VSP-37  
July 7, 1982

VENDOR SERVICE PUBLICATION

Subject: Bendix Service Bulletins 615, 620, 621

Figure 1. 10-157197 Distributor Gears with Different Timing Marks

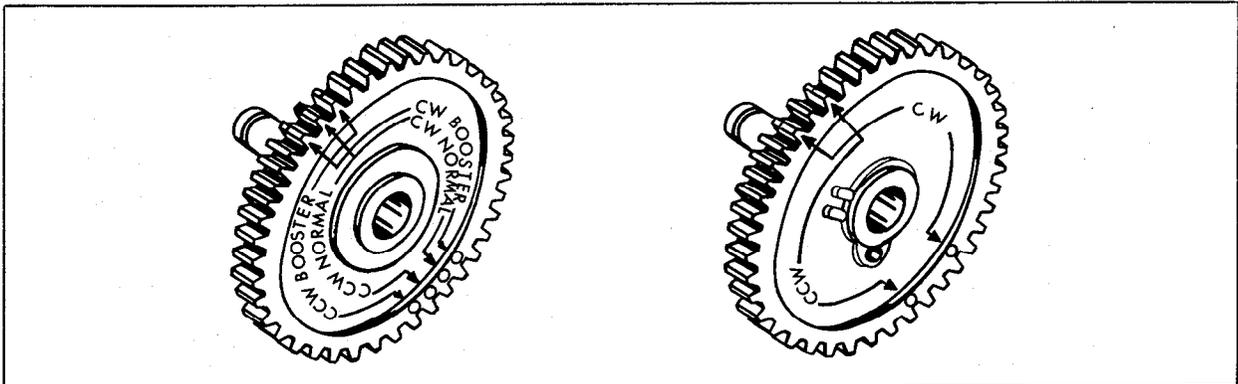
2. If old distributor gear, P/N 10-157197, which incorporated two different molded timing identification marks was used (see figure 1), proceed as follows:

- a. Remove paint from booster timing positions with suitable solvent.
- b. Locate normal timing tooth between CW and CCW booster chamfered teeth and paint this tooth and the applicable inner timing mark with red Dykem or red lacquer in accordance with figure 2 or figure 4 for appropriate gear.

Figure 3. Timing Marks on Present Production Distributor Gear Kit Assembly 10-357586

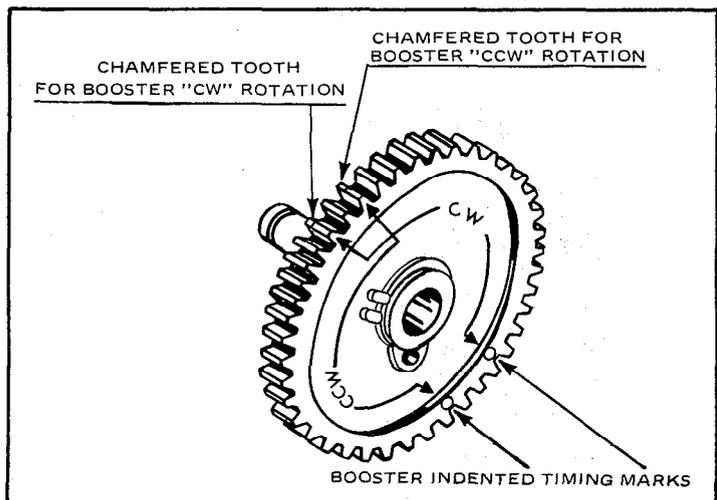
3. If present production distributor gear as supplied in kit P/N 10-357586 is used (see figure 3) proceed as follows:
  - a. Remove paint from booster timing positions with suitable solvent.
  - b. Locate normal timing tooth between CW and CCW booster chamfered teeth and paint this tooth and the applicable inner timing mark with red Dykem or red lacquer in accordance with figure 4.

Figure 4. Present Production Distributor Gear Assembly with Additional Timing Marks Painted

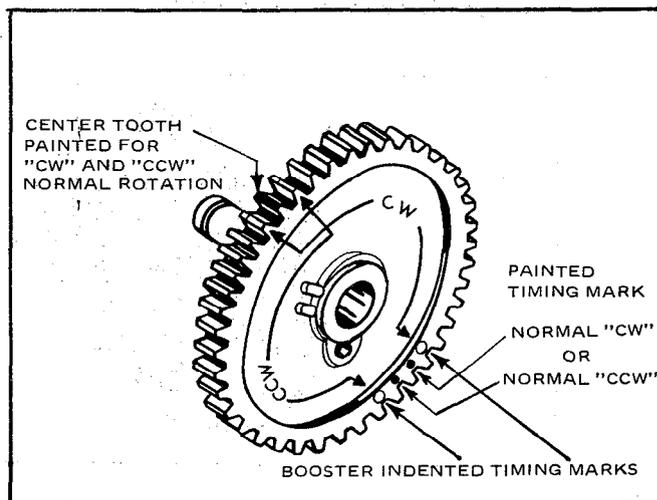
The molded timing marks incorporated in new present production nylon spare part gears, as supplied in kit, P/N 10-357586, are for the booster timing position. Before installation of a new gear kit, the applicable normal timing mark and center tooth must be marked with red

Dykem or red lacquer as illustrated in figure 4.

**Original Gear Make Up**  
*(Not incorporating insulating or plain steel skid washer.)*  
**Figure 1**

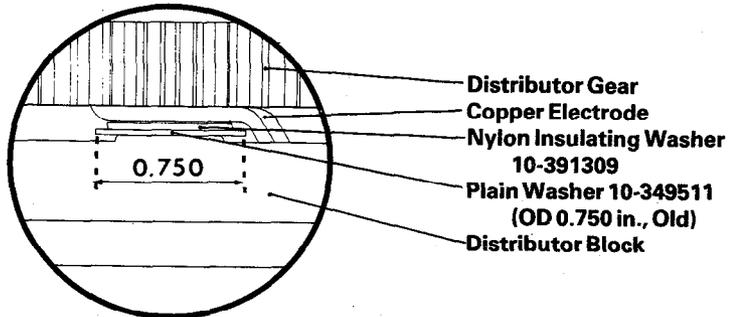
1. Remove the top timing plug.
2. Using a concentrated light beam (a pen light or equivalent) look into the timing hole at the area between the distributor gear and the distributor block parts for existing washer configuration.
3. Current configuration should be as shown in figure 3.
4. Rework magneto whenever configuration is as shown in figure 2.
5. An acceptable configuration is shown in figure 1.

**Insulated Gear Configuration**  
*(Incorporating 10-357586 Kit parts with incorrect washer.)*  
**Figure 2**

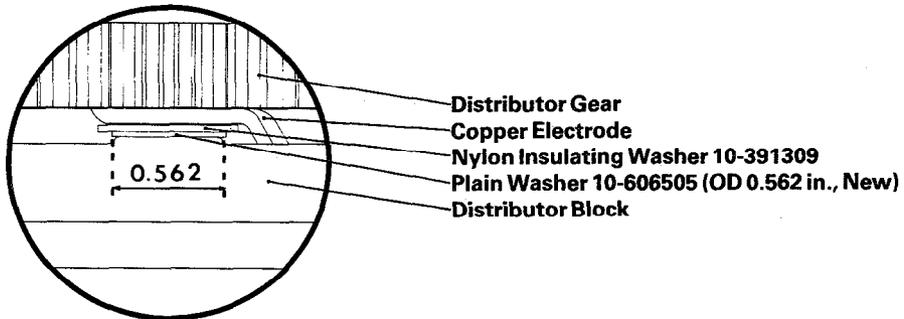
It has been determined that plain steel washer P/N 10-349511 installed on the gear axle between the nylon-insulating washer P/N 10-391309 and the distributor block bronze oil-lite bushing (see figure 2) can cause electrical flash-over in the distributor at altitude. Inspect for compliance as follows:
